Access Compliance Report

Public Rights-of-Way

(Curb Ramps)

Intersection ID: 11564	Main Street: BRIXTON_CT	Cross Street: HILLIARD_DR	Location: SE
ADA ID: DCD34534F4F6	Ramp Type: Perp	Initial Pass/Fail: Fail	Overall Compliance: No
		Severity Score: 8.75

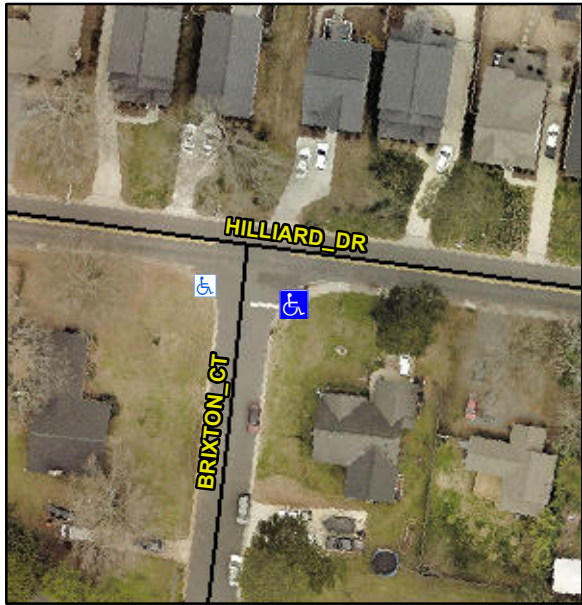
Codes/Mitigation Info/Possible Solution			Field Measurements/Component Compliance					
	Possible Solutions:		Compliance	Description	Data	Compliance	Description	Data
	Remove & Replace Entire Ramp.		N/A	Ramp Length (in)	73.0	Yes	Ramp Slope (%)	7.9
			No	Ramp Width (in)	47.5	Yes	Ramp XSlope (%)	0.5
			N/A	Flare Type LT	N/A	N/A	Flare Type RT	N/A
			N/A	Flare Slope LT (%)	N/A	N/A	Flare Slope RT (%)	N/A
			N/A	Flare Traversable LT?	N/A	N/A	Flare Traversable RT?	N/A
			N/A	Landing Length (in)	N/A	N/A	DWS Provided?	N/A
			N/A	Landing Width (in)	N/A	N/A	DWS Contrast?	N/A
			N/A	Landing Slope (%)	N/A	N/A	DWS Length (in)	N/A
			N/A	Landing X Slope (%)	N/A	N/A	DWS Full Width?	N/A
Surveyor Notes:	N/A		N/A	Landing Curb? (Y/N)	N/A	N/A	DWS Offset (in)	N/A
			N/A	Shared Landing?	N/A			
	PROW/ADA:		N/A	Gutter Ponding?	N/A	N/A	Gutter Slope (%)	N/A
	Not Found, R304.5.1		N/A	Gutter Lip Ht (in)	N/A	N/A	Gutter X Slope (%)	N/A

N/A	Painted X Walk1?	No	N/A	Painted X Walk2?	N/A
				X Walk 1 Direction	To NW		X Walk 2 Direction	N/A
			N/A	X Walk 1 Width (in)	N/A	N/A	X Walk 2 Width (in)	N/A
				X Walk 1 Slope (%)	3.3		X Walk 2 Slope (%)	N/A
				X Walk 1 X Slope (%)	2.6		X Walk 2 X Slope (%)	N/A
			N/A	Ramp inside XWalk1?	N/A	N/A	Ramp inside XWalk2?	N/A
				Road Slope (%)	N/A	N/A	Clear Space?	N/A
				Road X Slope (%)	N/A	N/A	Clear Space to XWalk (in)	N/A
			N/A	Any Obstructions?	N/A	N/A	Storm Grate/Utility Hazard?	N/A
				Obstruction Type			Storm Grate/Utility Type	
					N/A			N/A
						Yes	Surface Condition? (G/P)	Good
